Our Ref: PL/26/0628
Your Ref:

RE: PROPOSED WORKS TO 2NO. OAK TREES AT 23 MANDEVILLE CLOSE, TILEHURST, READING - T1 & T2 OF TREE PRESERVATION ORDER NUMBER 24/01.

I can therefore confirm that the following proposed works, as agreed during our site visit, are approved subject to the conditions below and with reference to the annotated photographs below:

Figure 6 (Oak T1 of Report; T2 of TPO): reduce branches growing towards No. 23 to provide clearance of the roof

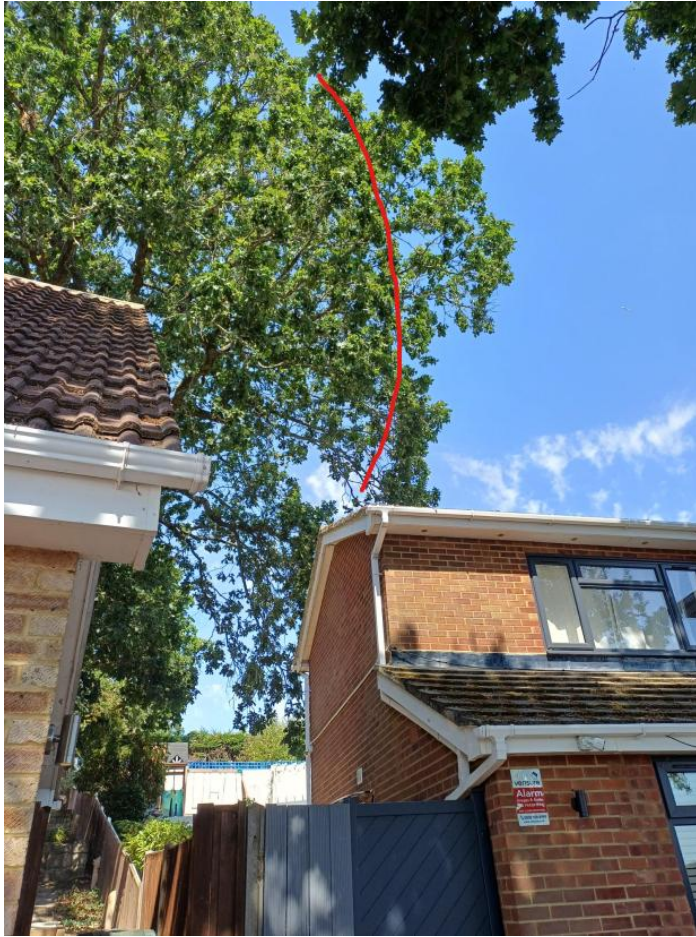
- Selectively reduce identified, overextended, lateral branches shown in Figures 6 & 7 by approximately 2-2.5m, using 'drop crotching' and in accordance with the BS3998 guidance as per Condition 2, creating approximately 2-3m clearance of the roofs of No. 23 and No. 25, bringing them back into the main crown line to form a natural canopy shape, ensuring no more than one third of the foliage is removed from each branch and leaving suitable growth points.

Figure 10 (Oak T1 of Report; T2 of TPO): remove one branch back into the point shown by the red arrow and straight red line; selectively reduce overextended branches by 1-1.5m to bring back into the main crown line shown by the red curve

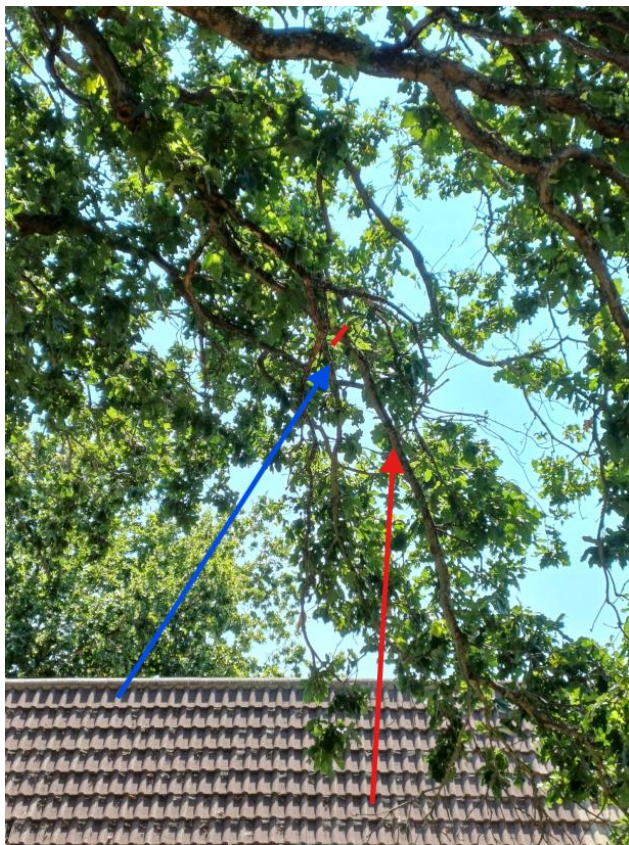
- Remove the identified lowest branch (growing west) in Figure 10 back to the point shown in Figure 10 (a previous pruning point); selectively reduce the identified, overextended branches as shown in Figure 10 by approximately 1-1.5m, bringing them back into the main crown line to form a natural canopy shape, ensuring no more than one third of the foliage is removed from each branch, leaving suitable growth points
